Crystal River Unit 3

Subject: Inservice Inspection Program (ISI) Supplement 1 to Relief Request 95-030

FLORIDA POWER CORPORATION  
INSERVICE INSPECTION  
RELIEF REQUEST # 95-030  
SUPPLEMENT 1  
CRYSTAL RIVER UNIT 3

PROJECT	FPC	CR-3	DATE	04-01-87	REV	0	DATE	04-15-92
TECHNICAL REVIEW	MANAGEMENT REVIEW		REF. ENG	N/A	REF. ENG	N/A	DRG. NO.	SK-1AC
APPROVED		APPROVED		APPROVED		APPROVED		2

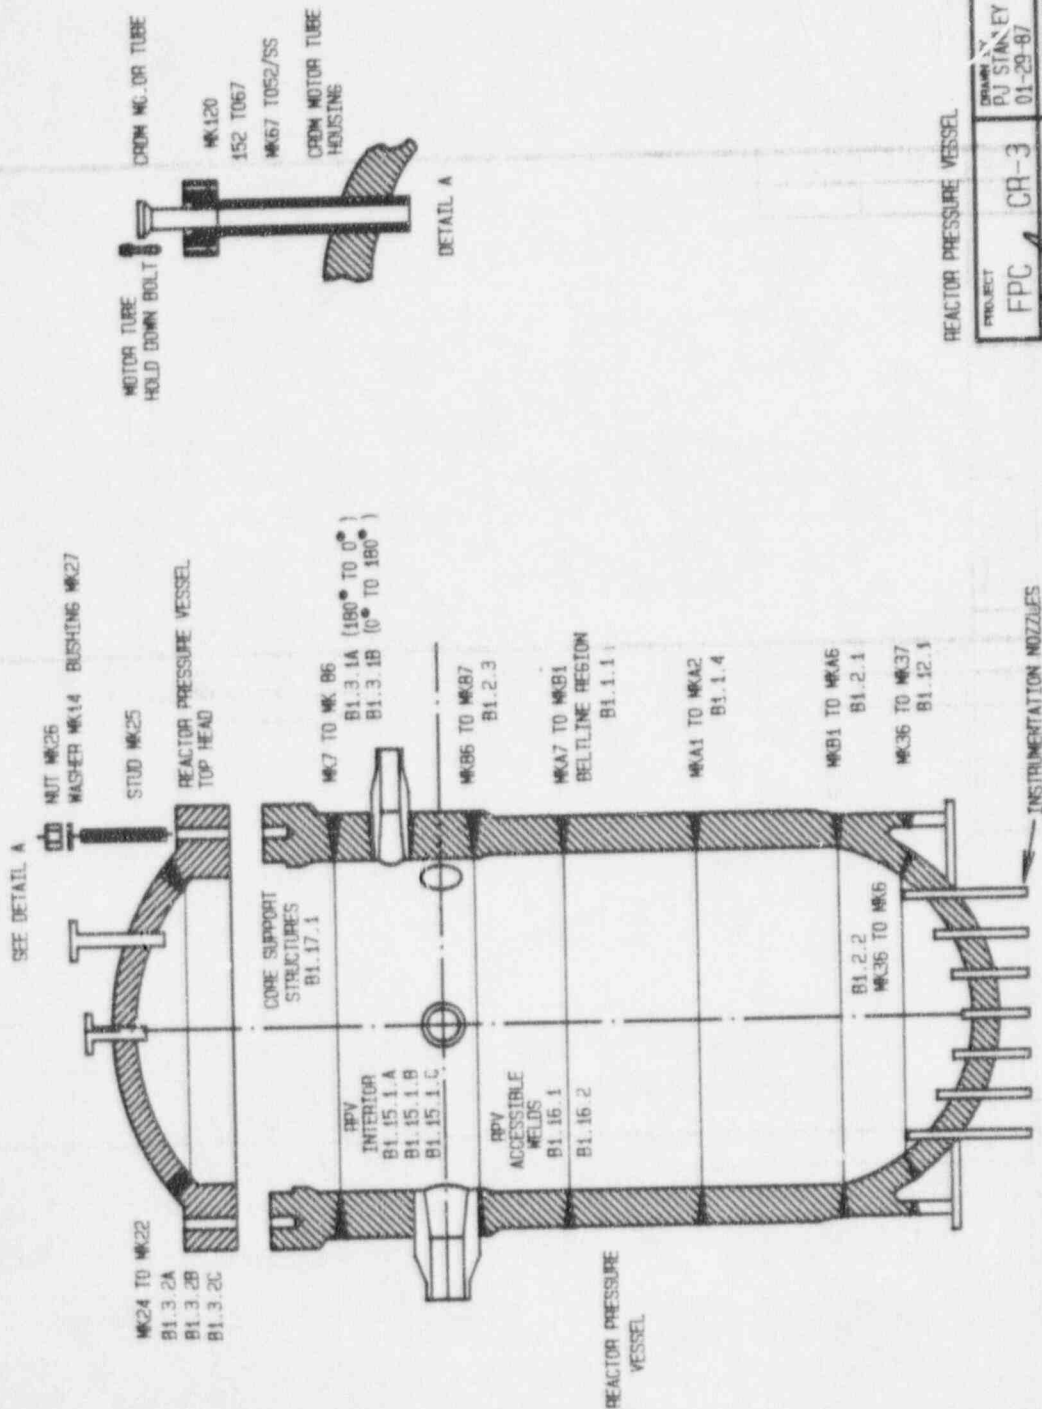
Reactor Vessel Transition Piece to Bottom Head Weld ISI Exam Number B1.2.2 (see attached sketch)

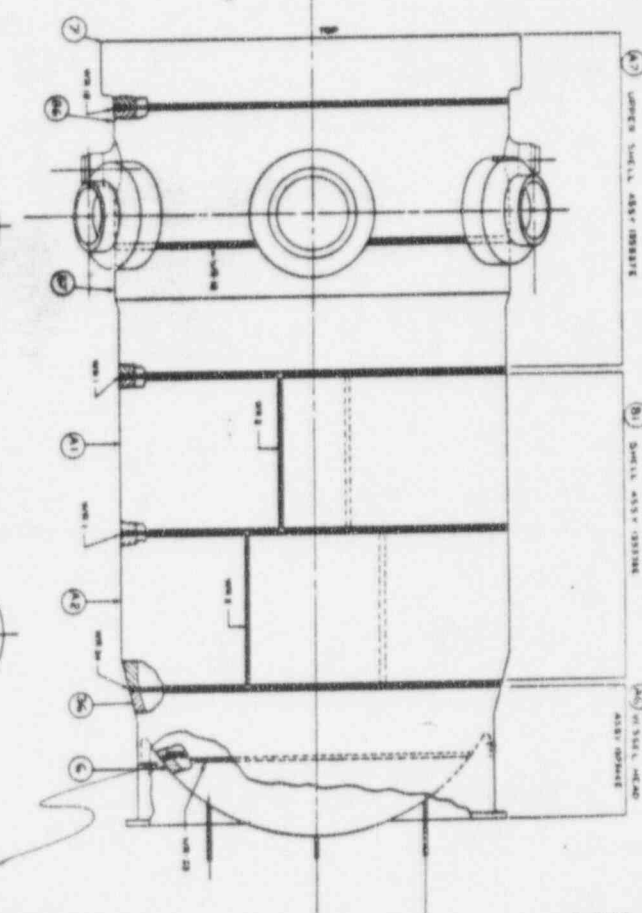
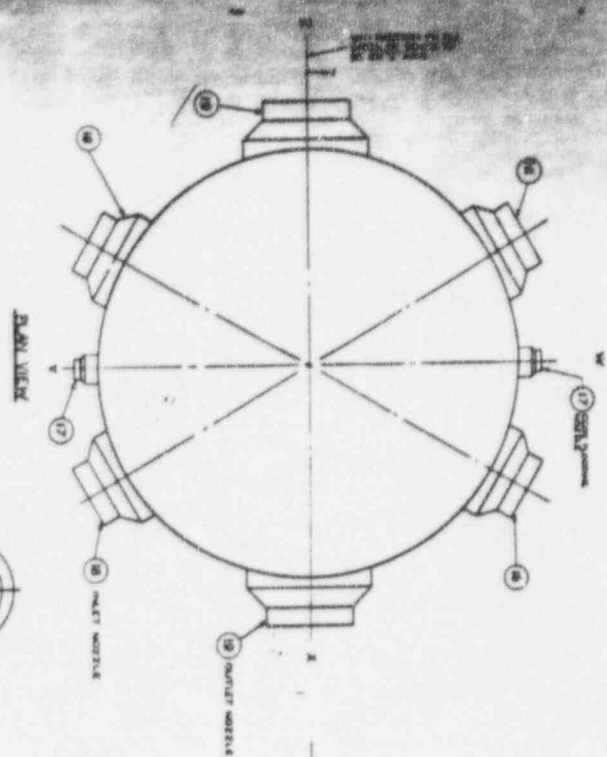
The licensee cites limited access for examination and the potential for damage of incore instrumentation by the examination tool. Provide a detailed access study and determine the actual probability for potential damage due to the inspection tooling, (i.e. considering clearance requirements, tool operations, etc.). In addition, provide instances where damage, if any associated with the subject weld has occurred, the result of the use of the inspection tool at your plant or at any other plant with similar reactor pressure vessel designs.

The Framatome robotic manipulator (URSULA) employs a two by two matrix of contact type ultrasonic transducers in the scanning head. In order to scan a weld, the transducer shoe must be in contact with the vessel surface. As can be seen from the attached drawings (B&W Dwg #'s 126951 and 135543) the area surrounding the lower head to transition piece weld is extremely congested with other reactor vessel components, such as the guide lugs, the incore instrumentation guide tubes, and the remnants of the lower flow stabilizers. The reactor vessel component of immediate concern, should an impact occur with the URSULA scanning head, are the incore instrument guide tubes. These slender tubes protrude from the inner surface of the lower head approximately 12 inches and are less than 1 inch in diameter. Alignment of these tubes is critical as they are inserted into a mating tube on the lower section of the core barrel when it is replaced. Any misalignment of these tubes due to an impact with the scanning head would cause significant damage not only to the incore guide tube, but also to the mating tube on the core support assembly and any adjacent tubes if significant deflection were to occur while installing the core barrel. Repair to the damaged incore instrumentation guide tube and any other affected components would cause significant critical path delays to the outage schedule.
